UNITED STATES PATENT AND TRADEMARK OFFICE

APPLICATION NO.	FILING DATE	FIRST NAMED INVENTOR	ATTORNEY DOCKET NO.	CONFIRMATION NO.
10/606,350	06/26/2003	Koji Maekawa	1767-116	3653
23117	7590	09/27/2005	EXAMINER	
NIXON & VANDERHYE, PC 901 NORTH GLEBE ROAD, 11TH FLOOR ARLINGTON, VA 22203			NELSON, JAMES T	
			ART UNIT	PAPER NUMBER
			3637

Office Action Summary

DETAILED ACTION

Hoffman, Fig. 2

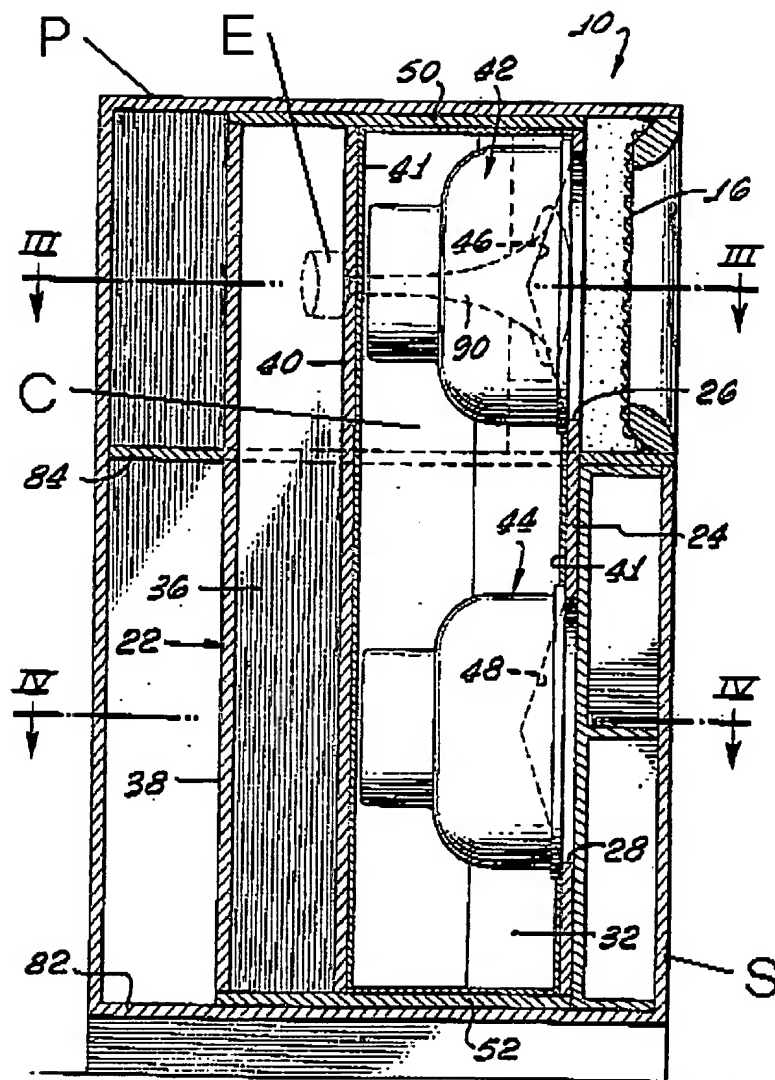
Regarding claim 1: In Fig. 2, Hoffman shows a speaker-provided mounting table (10) with a pedestal (P), a hollow-shaped support member (S) for supporting the pedestal (P), the support

Regarding claim 2: In Fig. 2, Hoffman shows a speaker-provided mounting table (10) according to claim 1, wherein the support member (S) is configured to function as an acoustic pipe with an acoustic capacity (C) associated with an acoustic pipe.

Regarding claim 3: In Fig. 2, Hoffman shows a speaker-provided mounting table (10) with a pedestal (P), a hollow-shaped support member (S) for supporting the pedestal, the support member (S) also functioning as an acoustic capacity (C) and a speaker unit (41) being equipped with a speaker (44) and attached to the support member (S).

Regarding claim 4: In Fig. 2, Hoffman shows a mounting table (10) according to claim 1, wherein the speaker unit (41) is composed of a dynamic electricity type of speaker (44).

Regarding claim 5: In Fig. 2, Hoffman shows a mounting table (10) according to claim 1, wherein the speaker unit (90) is composed of a piezoelectric type of speaker (E).

Regarding claim 9: In Fig. 2, Hoffman shows a mounting table (10) according to claim 3, wherein the support member (S) has an acoustic capacity (C) to cause a resonance with a vibration mass (48) of the speaker unit (44).

Regarding claim 6: In Fig. 2, Hoffman shows a mounting table according to claim 1, wherein the support member (S) is provided with an acoustic capacity cavity (C), but lacks an aperture port for outputting the sound emitted by the acoustic capacity cavity. In Fig. 2, Wilke teaches an aperture port (80) for outputting the sound emitted by the acoustic capacity cavity (5). It would have been obvious to one skilled in the art at the time of invention to combine the aperture port of Wilke with the support member of Hoffman in order output sound emitted by the acoustic capacity cavity.

Regarding claim 7: In Fig. 2, Hoffman shows a mounting table according to claim 1, with a support member (S), but lacks an acoustic pipe for causing a pipe resonance therein and an aperture port for outputting sound generated by the pipe resonance. In Fig. 2, Wilke teaches an acoustic pipe (70) for causing a pipe resonance therein and an aperture port (80) for outputting sound generated by the pipe resonance. It would have been obvious to one skilled in the art at the time of invention to combine the acoustic pipe and aperture port of Wilke with the support member of Hoffman in order to create a pipe resonance and output the sound generated by the pipe resonance.

Regarding claim 8: In Fig. 2, Hoffman shows a mounting table according to claim 2, wherein the support member (S) is provided with an acoustic capacity (C), but lacks an acoustic pipe, which causes a resonance therein, and an aperture port for outputting sound generated by the resonance. In Fig. 2, Wilke teaches an acoustic pipe (70), which causes a resonance therein, and an aperture port (80) for outputting sound generated by the resonance. It would have
